GRADING/PAVING PLAN

ENGINEER CERTIFICATION FOR (G16-D027)

Job Title
AZTEC LLC WAREHOUSE/OFFICE
2417 AZTEC DRIVE N.E.
ALBUQUERQUE, NEW MEXICO

RECEIVED
JUL 2 2 2011
HYDROLOGY
SECTION

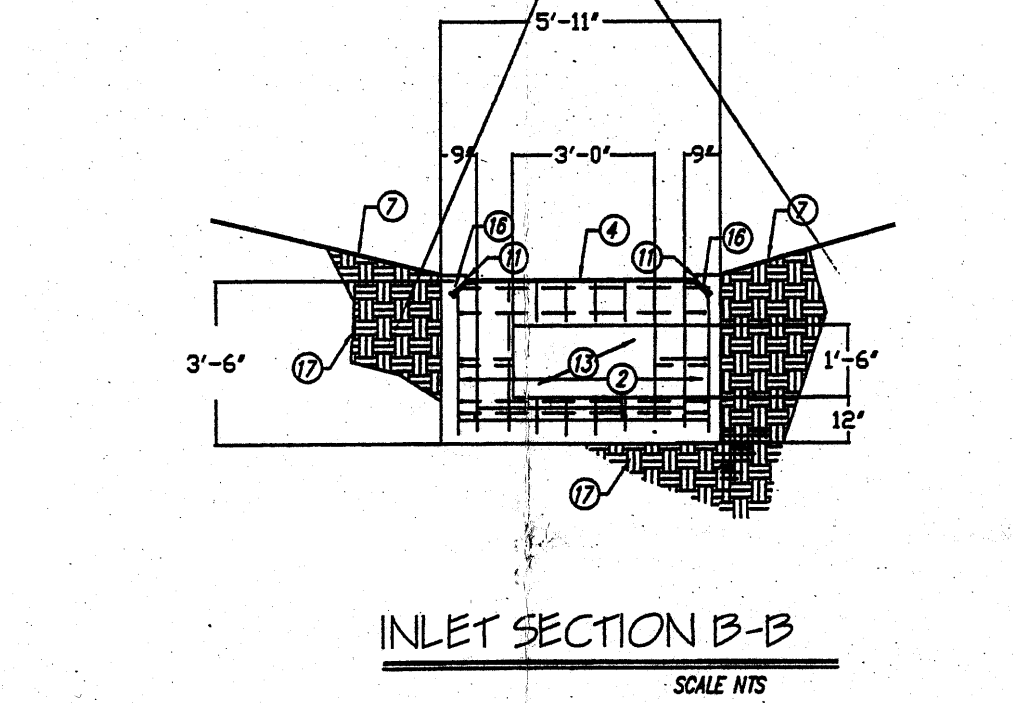
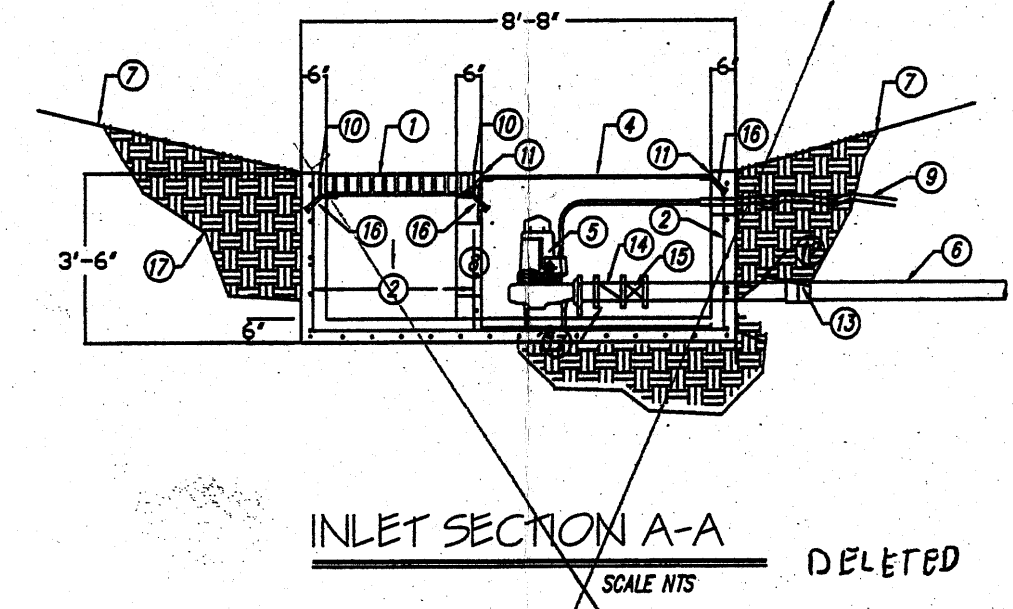
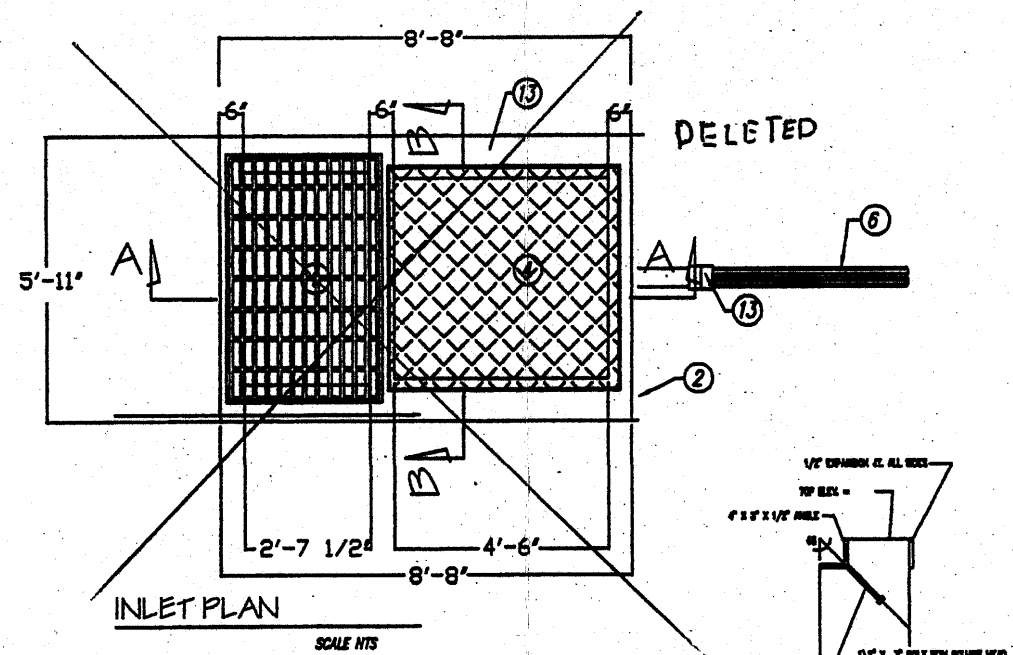
- THE EASTERN PORTION OF BASIN A AND ALL OF BASIN B HAVE BEEN CHANGED TO ASPHALT MILLINGS
- PROPOSED INLET WITH PUMP SYSTEM HAS BEEN CHANGED TO A SINGLE "D" INLET (DWG. 2206) WHICH NOW CONNECTS TO A MANHOLE LIFT STATION (SEE PLAN DRAWING)
- LIFT STATION IS DRAINED VIA A 3" STEEL PIPE ATTACHED ALONG THE WEST SIDE OF BUILDING. DOCK SUMP IS ALSO ATTACHED TO THE 3" STEEL PIPE (SEE PLAN DRAWING).
- THE 3" STEEL PIPE NOW DRAINS FROM THE SOUTHWEST CORNER OF THE BUILDING UNDERGROUND TO THE SOUTHWEST CORNER OF THE PROPERTY AND THROUGH A DRAIN LINE THRU THE CURB (S019 DWG. 2235). SEE PLAN DRAWING

AS-BUILT DESIGNATION
TC 97.65
FL 97.50
OR
97.50

GRADING & PAVING PLAN

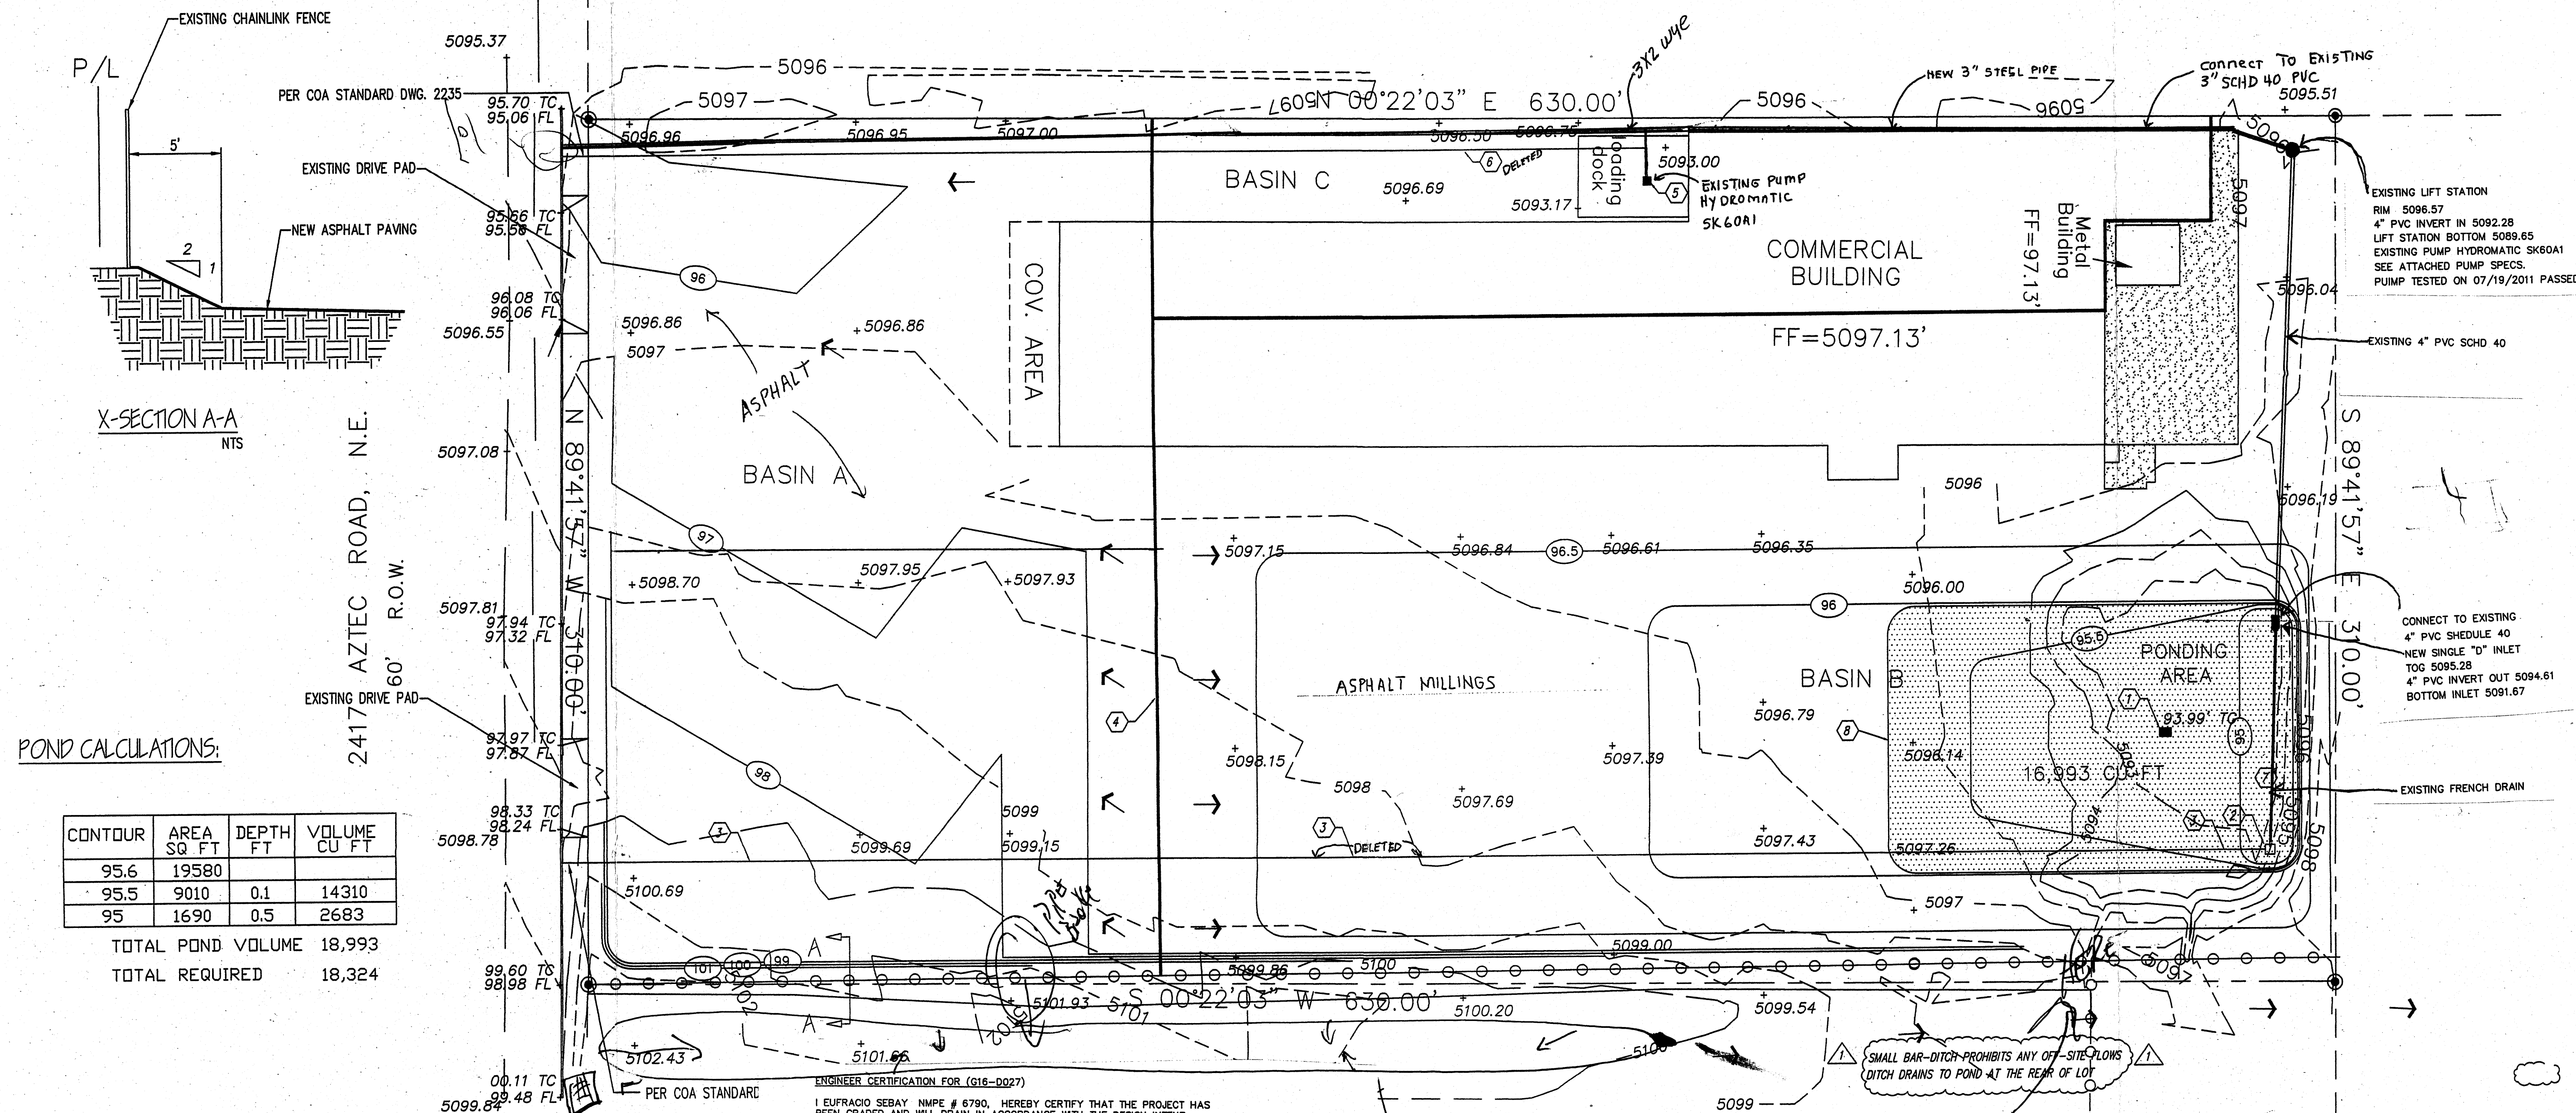
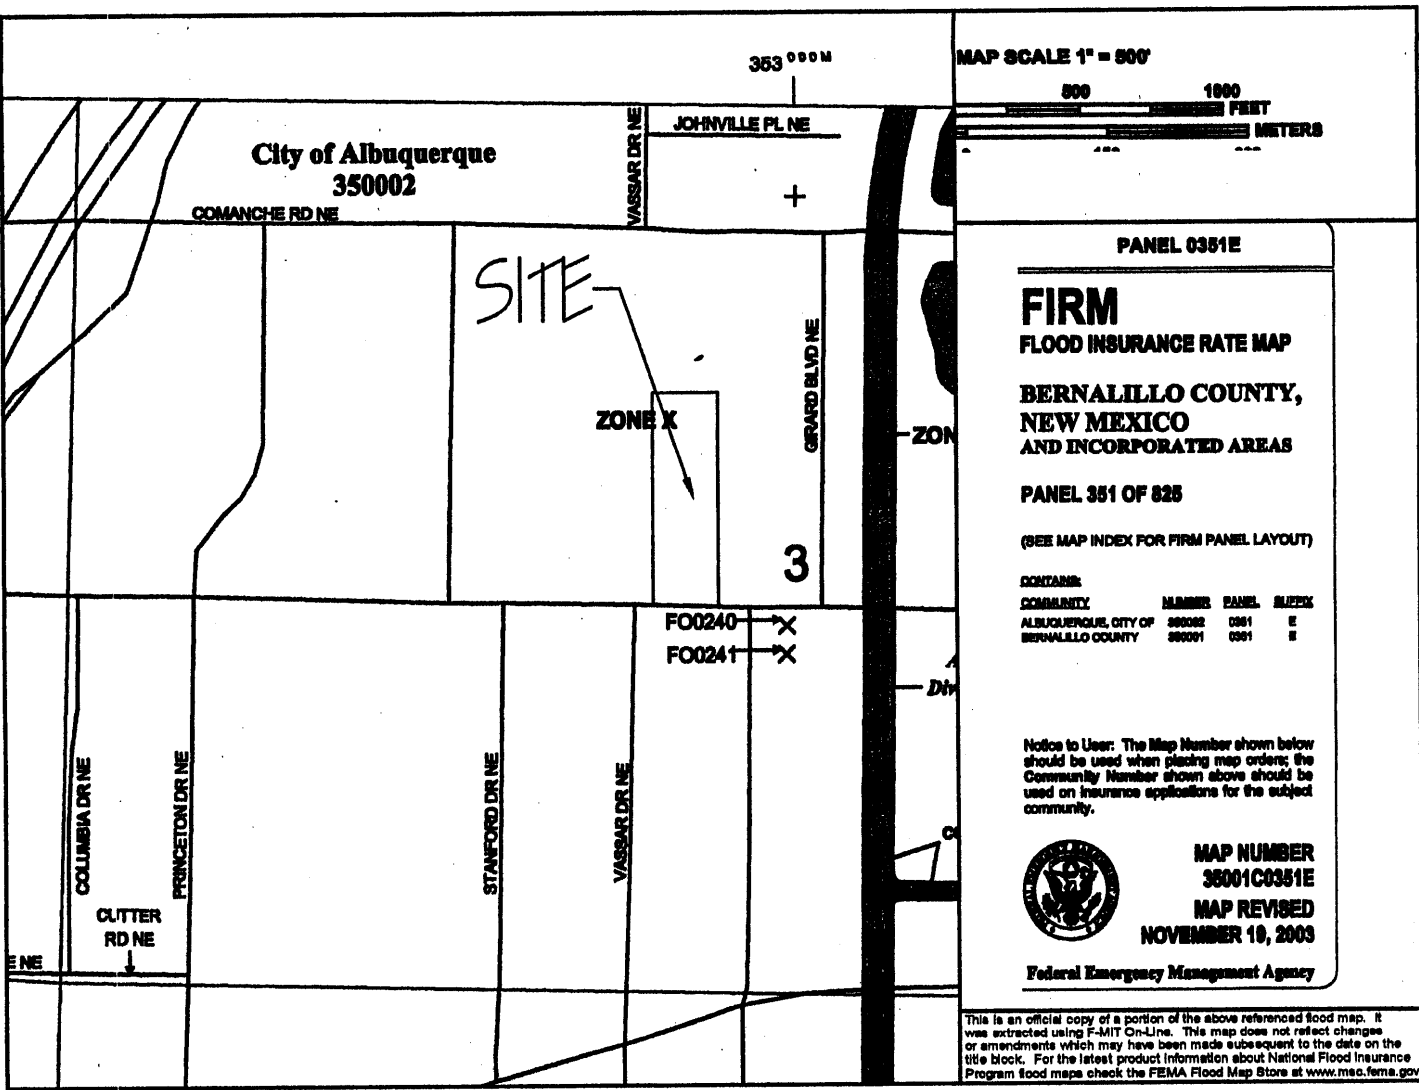
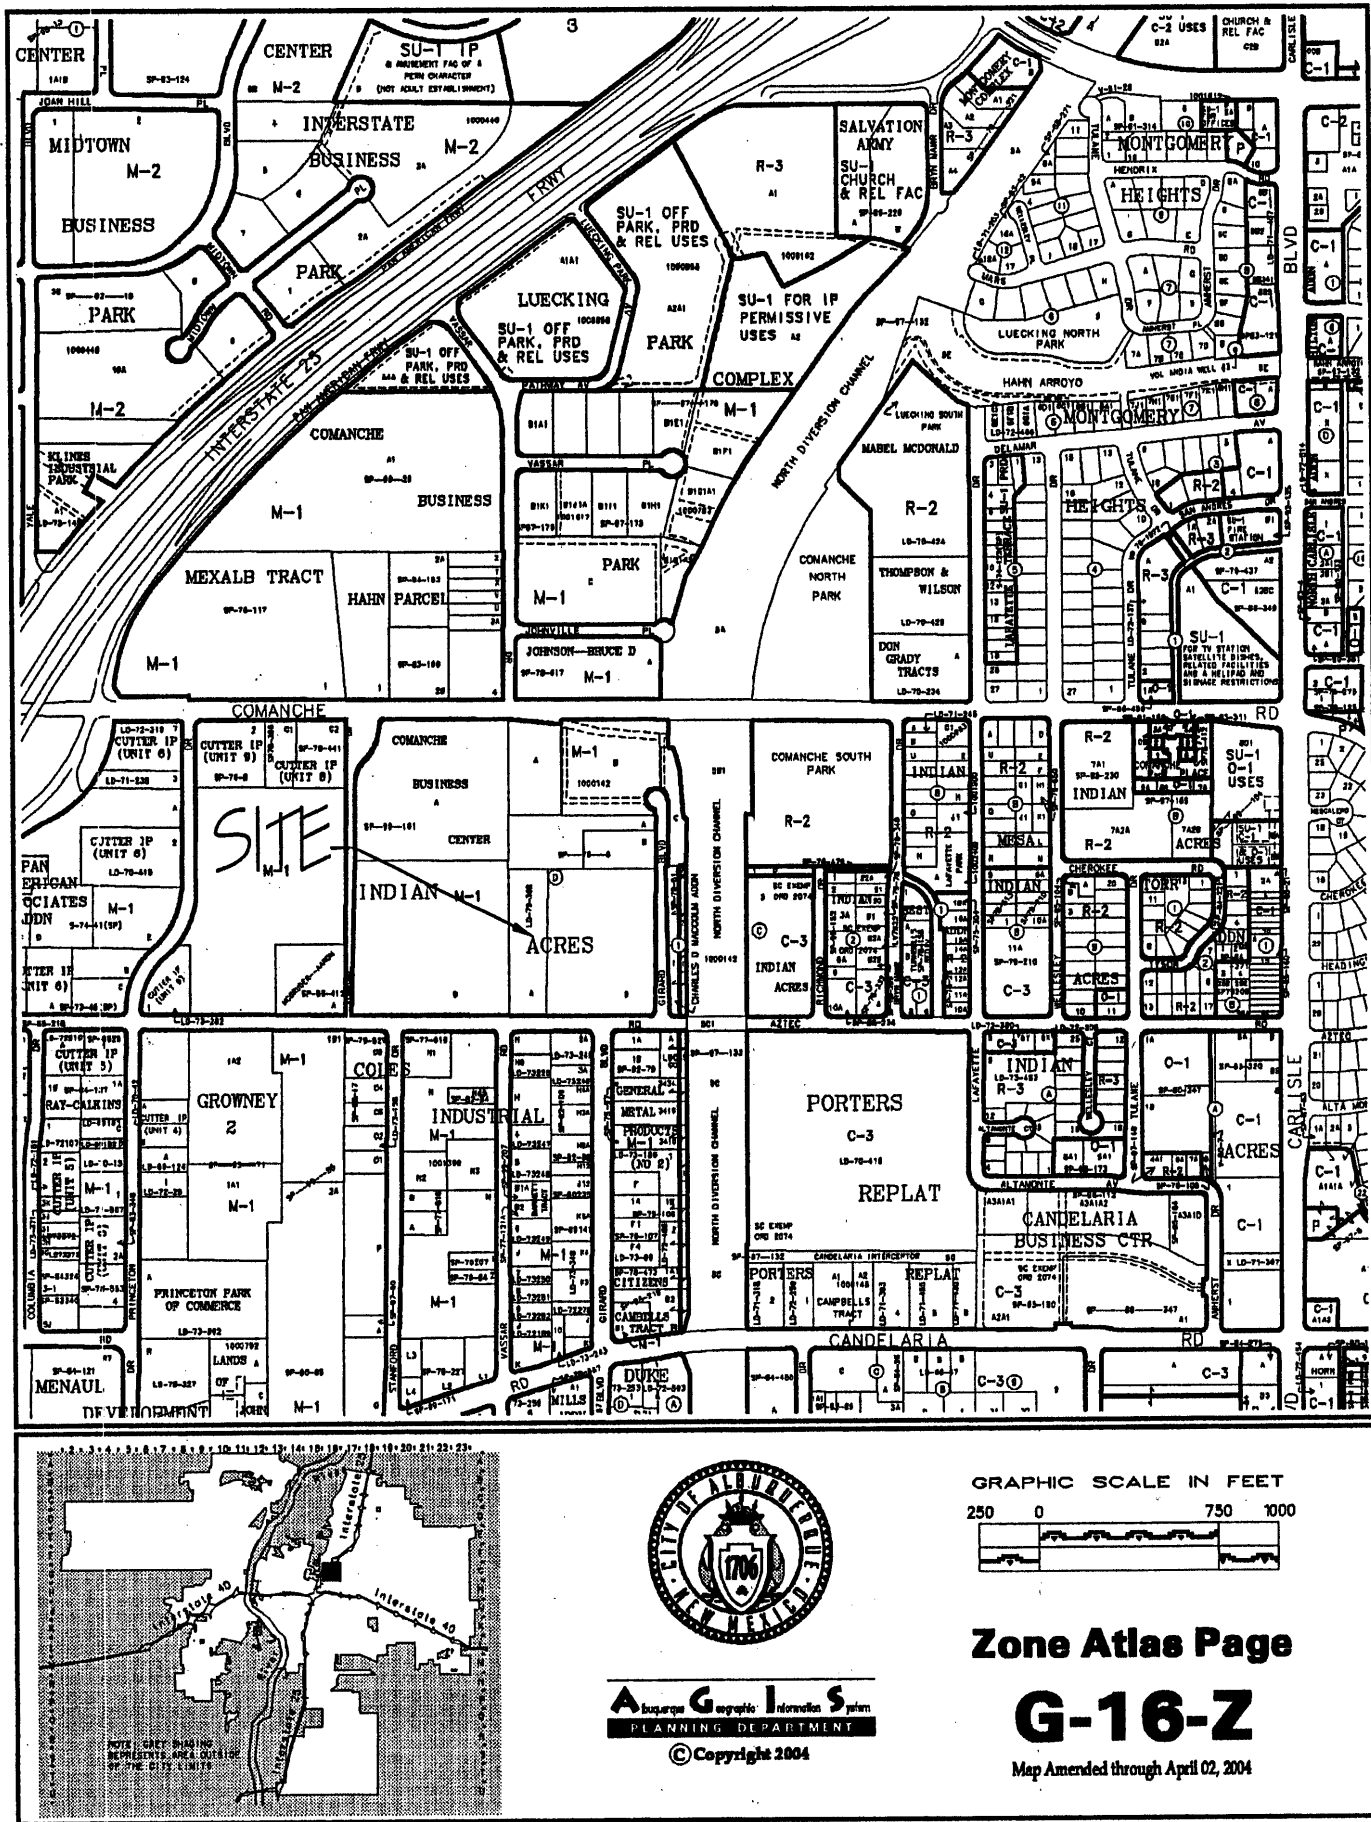
AS-BUILT DESIGNATION
TC 97.65
FL 97.60
OR
97.50✓
